Access Report

University of Sydney ETP Stage 1
Alterations & Additions to an existing University building

Development Application Design Phase

Date - 30 November 2017
For - Laing O'Rourke Australia Construction Pty Ltd
Ref - 17380 – R1.1

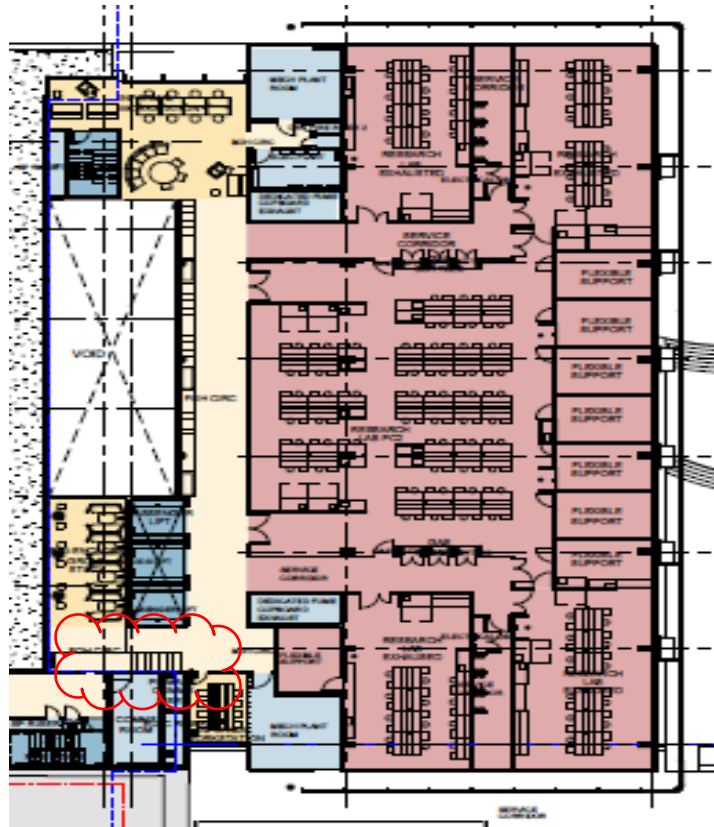
Design Detail	<p>Access is required to and throughout the areas of 'new work' and the Affected Part' (per report Part 2.0) in accordance with AS 1428.1-2009.</p> <p><u><i>DTS Compliance Departure 1</i></u></p> <p>An accessible path of travel is not provided across the split level at Level 9.</p> <p>Stairs are provided at the point(s) of interconnection between the split levels and causes an access barrier and a DTS compliance departure with this clause.</p> <p><u><i>Resolution option(s) 1</i></u></p> <p>The client will pursue a <i>BCA Performance Solution</i> to demonstrate the suitability of the current design at the Construction Certificate design phase. Hence, no concern for adjustment at the CC design phase.</p> <p>Reliance will be placed upon (amongst other things) –</p> <ol style="list-style-type: none"> Enhanced way-finding signage. Passenger lift provision is provided at both split levels, hence, access is available to all building parts, although not direct.

See below plan extract which illustrates the stairs / access barrier outlined **Red**.

- c. 8 of 9 floors includes compliant access between split levels. This is a good access outcome in an existing building.
- d. Existing building constraints.
- e. A reduced extent of work to the existing building part at the lower tier, therefore, whilst an 'affected part' access upgrade trigger is caused, the extent of work causing the trigger is nominal.
